# CITY OF ALBUQUERQUE

June 2, 2023

**Re: San Mateo Mixed-use Affordable Housing**  
**1000 San Mateo Blvd. SE**  
**Traffic Circulation Layout**  
Architect's Stamp 05-18-23 (L18-D087)

3 5-SPACE BIKE RACK DETAIL  
3/4" = 1'-0"

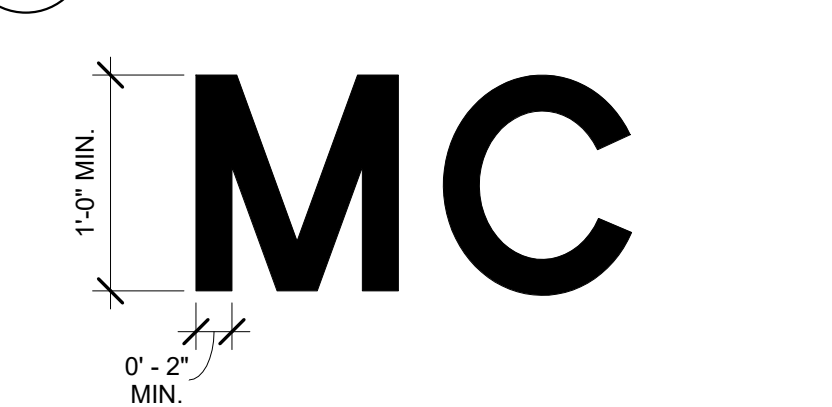
7. Provide Motorcycle parking signage.
8. Label the compact parking spaces by placing the words “**COMPACT**” on the pavement of each space.
9. All bicycle racks shall be designed according to the following guidelines:

- a. The rack shall be a minimum 30 inches tall and 18 inches wide.
  - b. The bicycle frame shall be supported horizontally at two or more places. Comb/toaster racks are not allowed.

- c. The rack shall be designed to support the bicycle in an upright position. See the IDO for additional information.
  - d. The rack allows varying bicycle frame sizes and styles to be attached.

- e. The user is not required to lift the bicycle onto the bicycle rack.
  - f. Each bicycle parking space is accessible without moving another bicycle.

10. Bicycle racks shall be sturdy and anchored to a concrete pad.
11. A 1-foot clear zone around the bicycle parking stall shall be provided.
12. Bicycle parking spaces shall be at least 6 feet long and 2 feet wide.

1 TRAFFIC CIRCULATION LAYOUT - SITE PLAN  
1" = 20'-0"

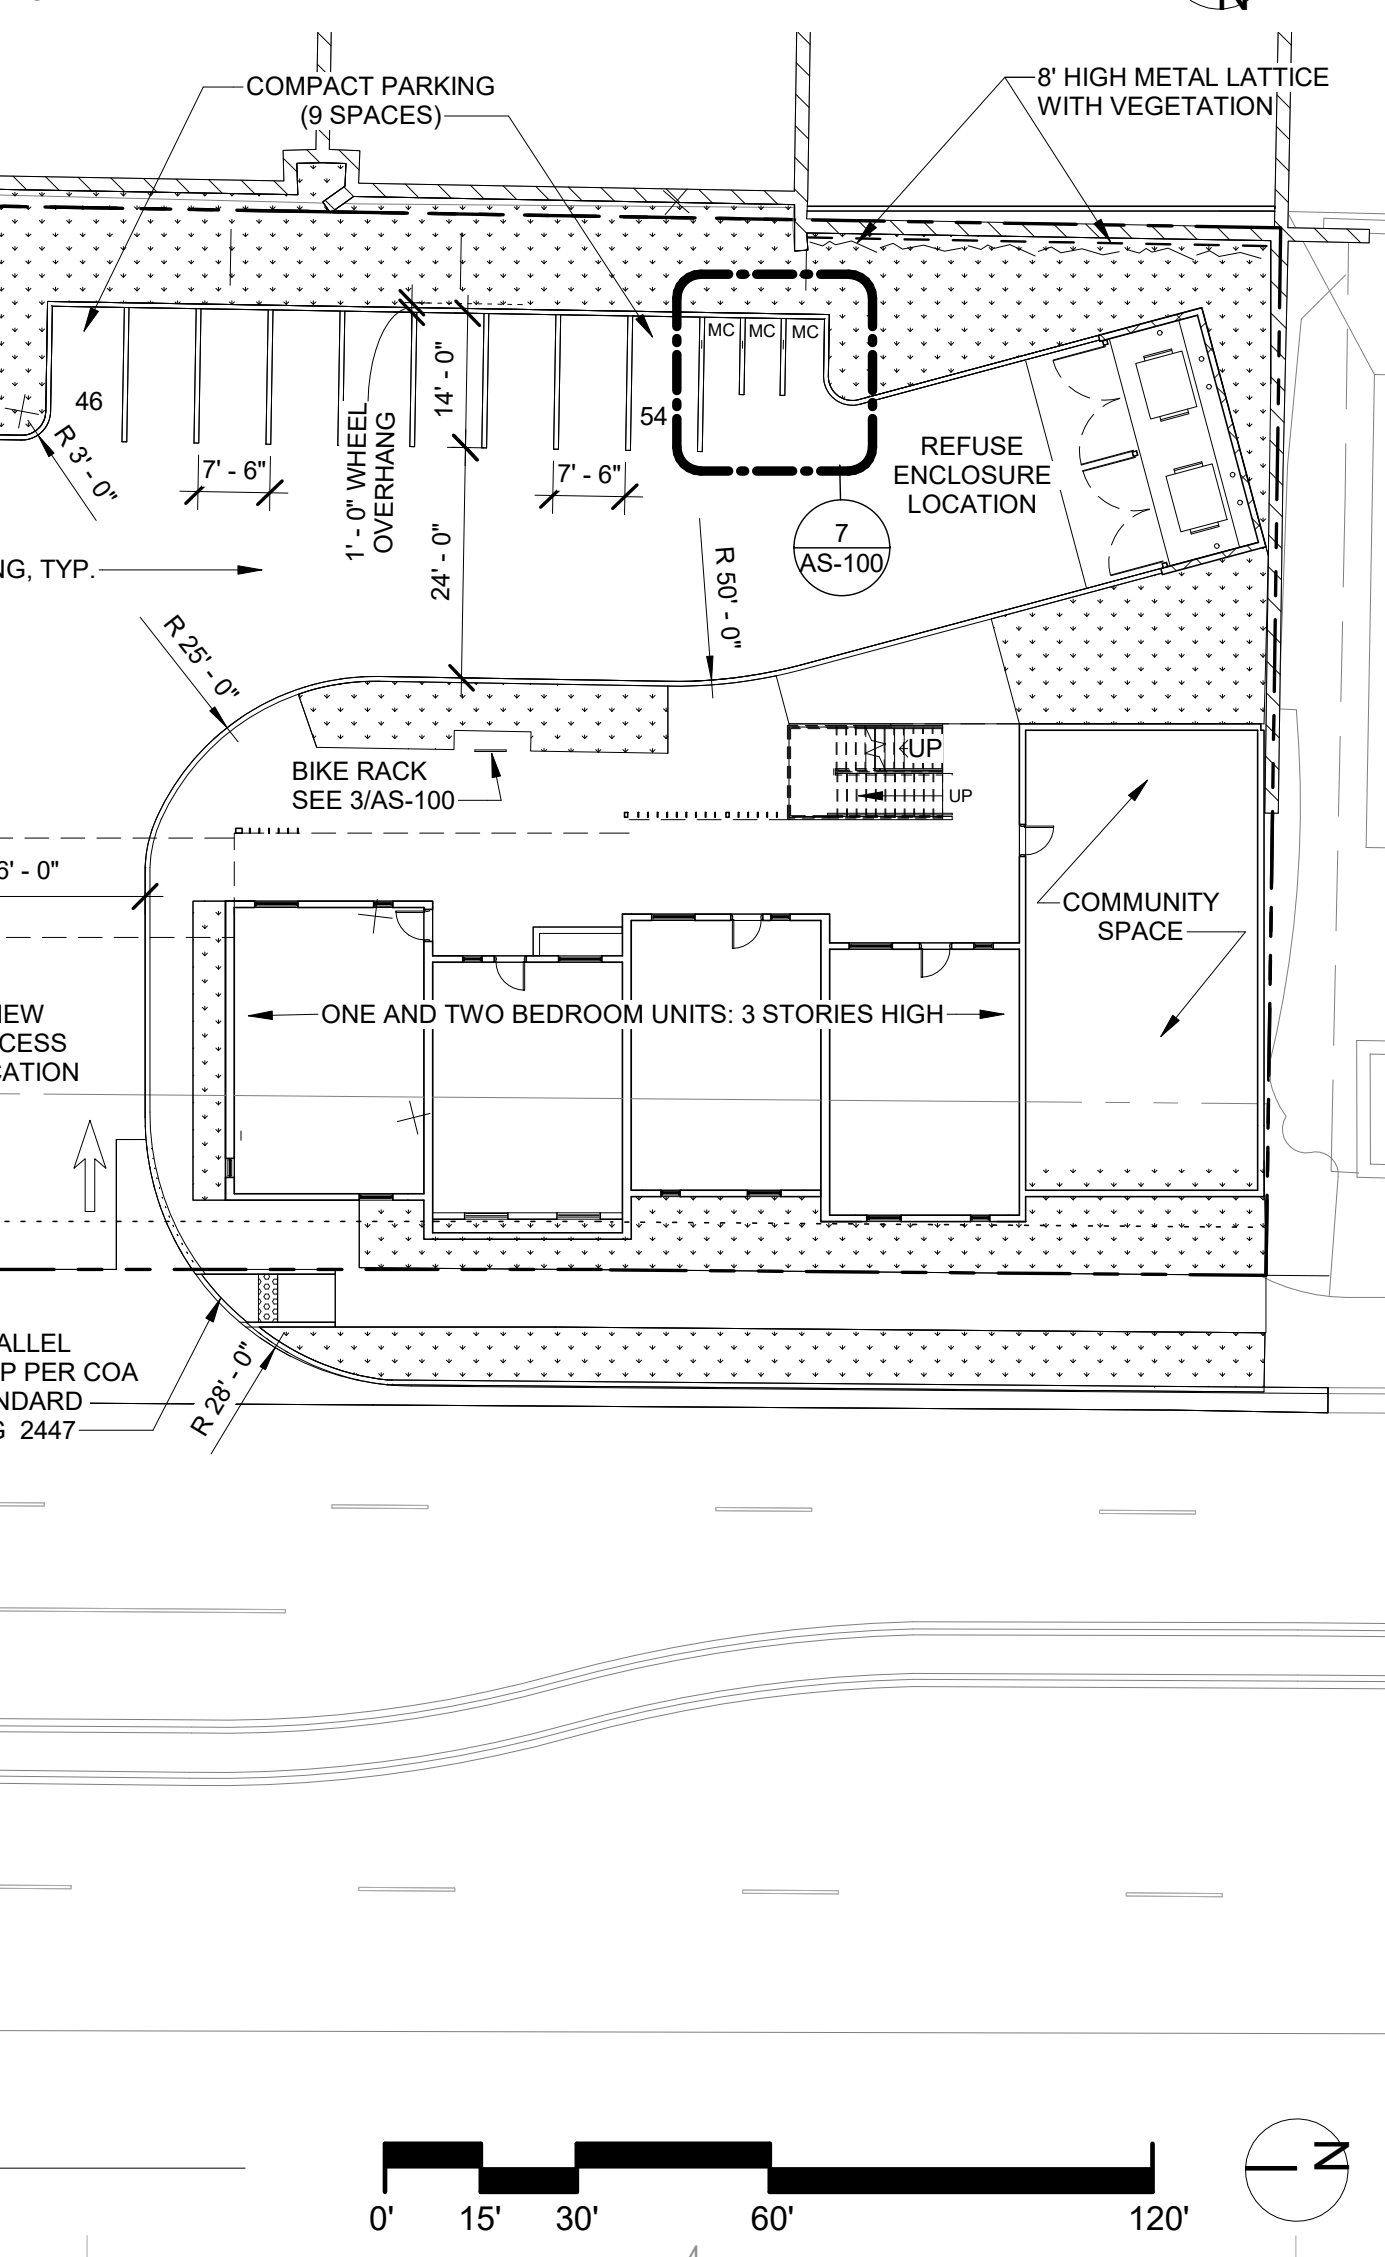
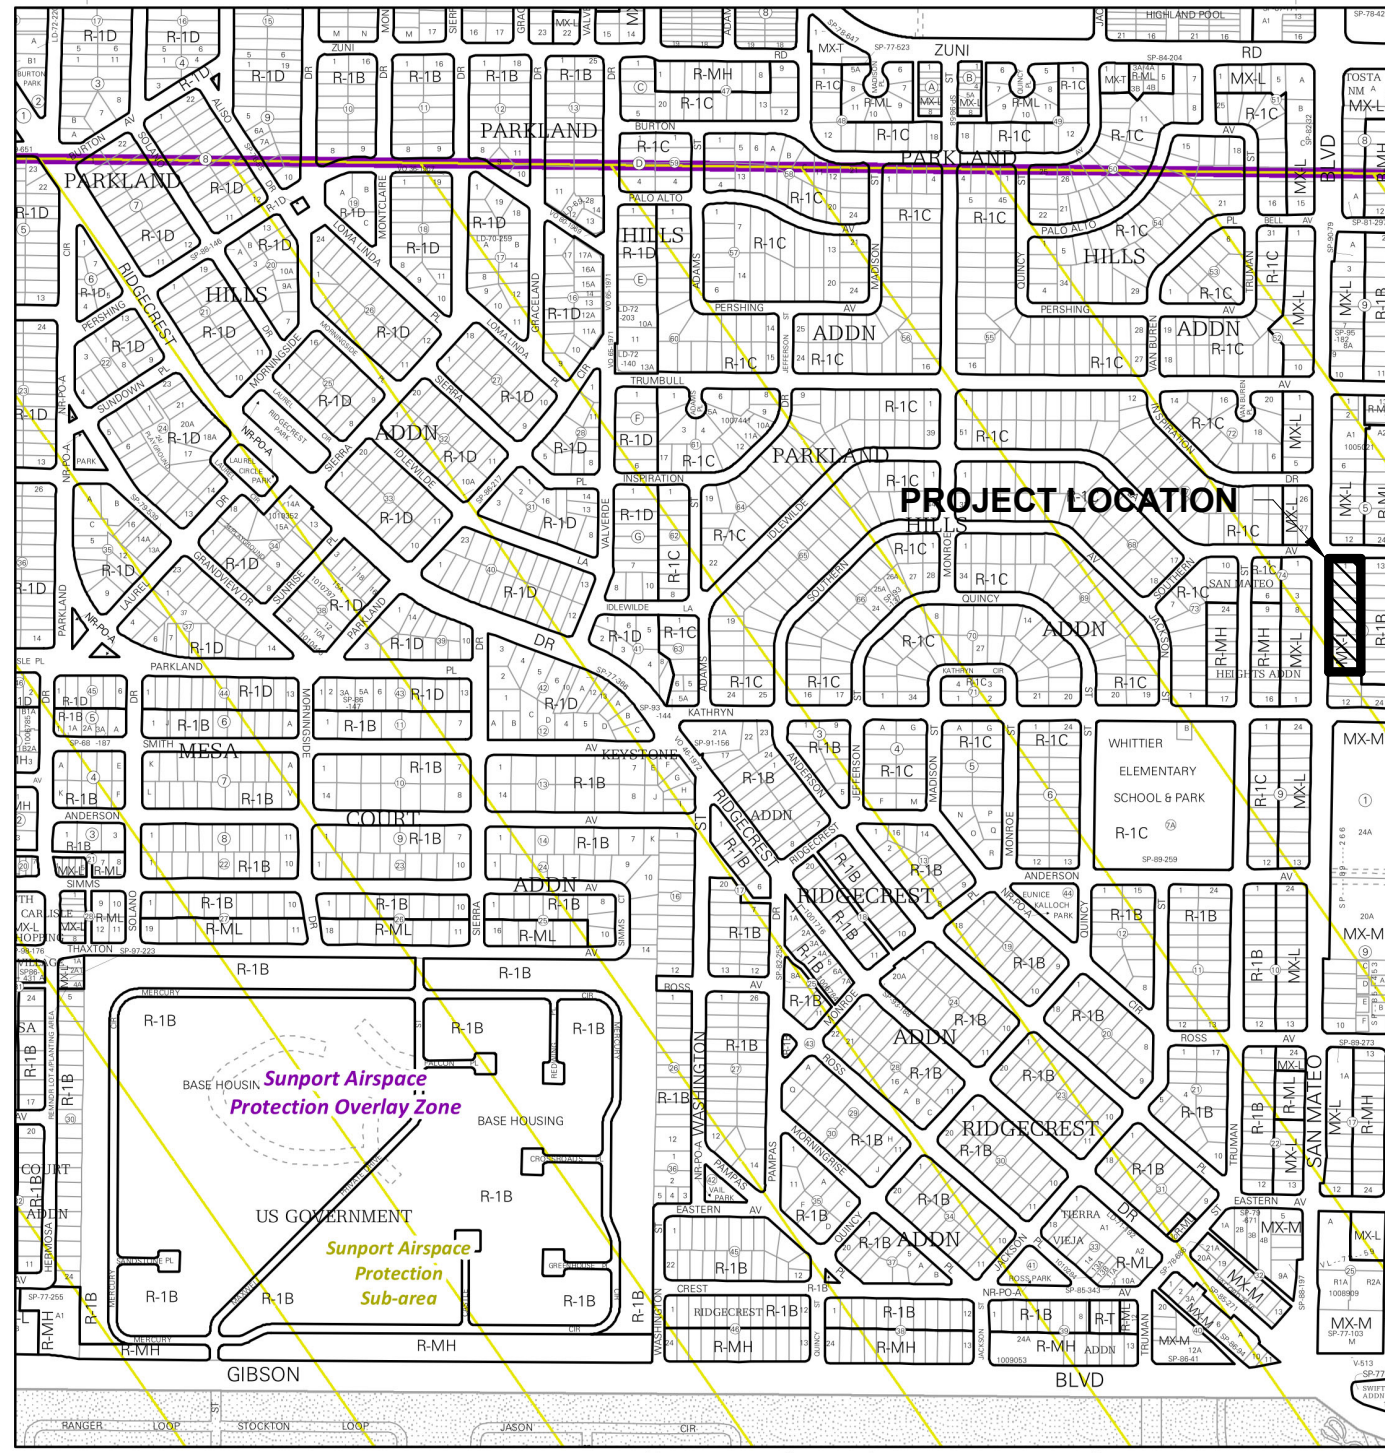
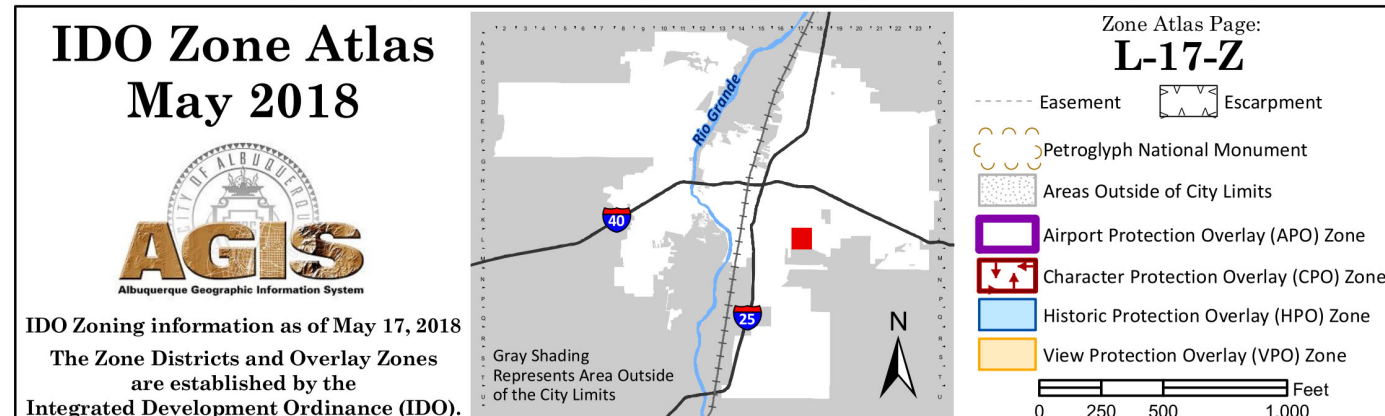
1. Identify all existing access easements, existing sidewalk width, and rights of way width dimensions.
2. Identify the right of way width, medians, curb cuts, and street widths on San Mateo Blvd. and Southern Ave.
3. The proposed site plan does not match the Google aerial. Please address this concern.

4. The minimum distance from the intersection of San Mateo and Southern Ave. to site access off Southern Ave. is 75 ft. please show this dimension on the site plan.
5. The minimum throat depth for the site access off San Mateo Blvd. is 50 ft. please show this dimension on the site plan.
6. The minimum stall length is 18 ft. please see the minimum parking stall dimensions table:

13. Per the IDO, a 6 ft. wide ADA accessible pedestrian pathway is required from the public sidewalk to the building entrances. Please clearly show this pathway and provide details.

14. Curbing should be installed to delineate landscape, parking, and pedestrian ways and identify points of access. Please call out detail and location of barrier curb.

15. Parking areas shall have barriers to prevent vehicles from extending over public sidewalk, public right-of-way, or abutting lots.
16. Refuse vehicle maneuvering shall be contained on-site. The refuse vehicle shall not back into the public right of way.; provide a copy of refuse approval.

17. Provide a copy of Fire Marshal approval.
18. It is not apparent what type of pavement surface is being proposed. A hard driving surface will be required as part of this proposed project for parking area and drive aisles.

19. Show the Intersection clear sight triangle for site access off San Mateo Blvd. and add the following note to the plan: “Landscaping and signage will not interfere with clear sight

requirements. Therefore, signs, walls, trees, and shrubbery between 3 and 8 feet tall (as measured from the gutter pan) will not be acceptable in the clear sight triangle.

20. Show the mini clear sight triangle for the site access off Southern Ave.
21. Please specify the City Standard Drawing Number when applicable.
22. Add a note stating "All broken or cracked sidewalk must be replaced with sidewalk and curb & gutter." A build note must be provided referring to the appropriate City Standard drawing.
23. Please provide a letter of response for all comments given.
24. Traffic Studies: See the Traffic Impact Study (TIS) thresholds. In general, a minimum combination of 100 vehicles entering and exiting in the peak hour warrants a Traffic Impact Study. Visit with Traffic Engineer for determination, and fill out a TIS Form that states whether one is warranted. In some cases, a trip generation may be requested for determination (**Contact Matt Grush: [mgrush@cabq.gov](mailto:mgrush@cabq.gov)**).
